Access Compliance Report

Public Rights-of-Way

(Curb Ramps)

Intersection ID: 31171	Main Street: POINTER_RD	Cross Street: BROWNE_RD	Location: NW
ADA ID: BD8472822641	Ramp Type: Perp	Initial Pass/Fail: Fail	Overall Compliance: No
Severity Score: 10			
Codes/Mitigation Info/Possible Solution		Field Measurements/Component Compliance

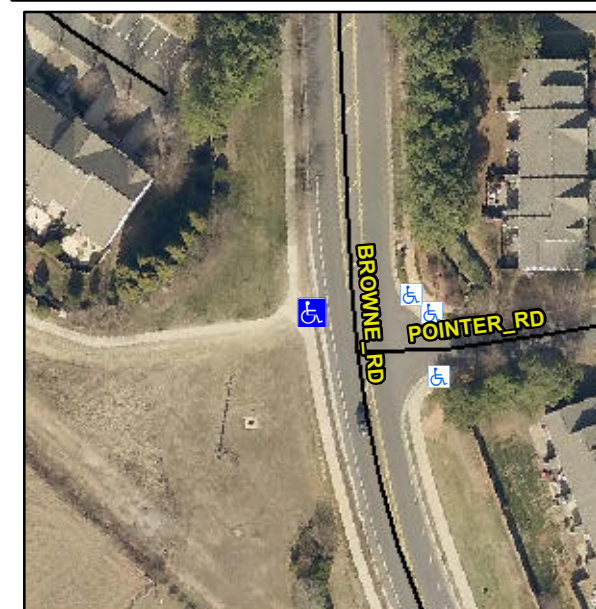
Possible Solutions:

Remove & Replace Entire Ramp.

PROW/ADA:

R304.5.1, R304.5.3

Compliance	Description	Data	Compliance	Description	Data
N/A	Ramp Length (in)	84.0	Yes	Ramp Slope (%)	5.8
No	Ramp Width (in)	47.5	No	Ramp XSlope (%)	2.9
N/A	Flare Type LT	N/A	N/A	Flare Type RT	N/A
N/A	Flare Slope LT (%)	N/A	N/A	Flare Slope RT (%)	N/A
N/A	Flare Traversable LT?	N/A	N/A	Flare Traversable RT?	N/A
N/A	Landing Length (in)	N/A	N/A	DWS Provided?	N/A
N/A	Landing Width (in)	N/A	N/A	DWS Contrast?	N/A
N/A	Landing Slope (%)	N/A	N/A	DWS Length (in)	N/A
N/A	Landing X Slope (%)	N/A	N/A	DWS Full Width?	N/A
N/A	Landing Curb? (Y/N)	N/A	N/A	DWS Offset (in)	N/A
N/A	Shared Landing?	N/A			
N/A	Gutter Ponding?	N/A	N/A	Gutter Slope (%)	N/A
N/A	Gutter Lip Ht (in)	N/A	N/A	Gutter X Slope (%)	N/A
N/A	Painted X Walk1?	No	N/A	Painted X Walk2?	N/A
	X Walk 1 Direction	To E		X Walk 2 Direction	N/A
N/A	X Walk 1 Width (in)	N/A	N/A	X Walk 2 Width (in)	N/A
	X Walk 1 Slope (%)	4.0		X Walk 2 Slope (%)	N/A
	X Walk 1 X Slope (%)	2.5		X Walk 2 X Slope (%)	N/A
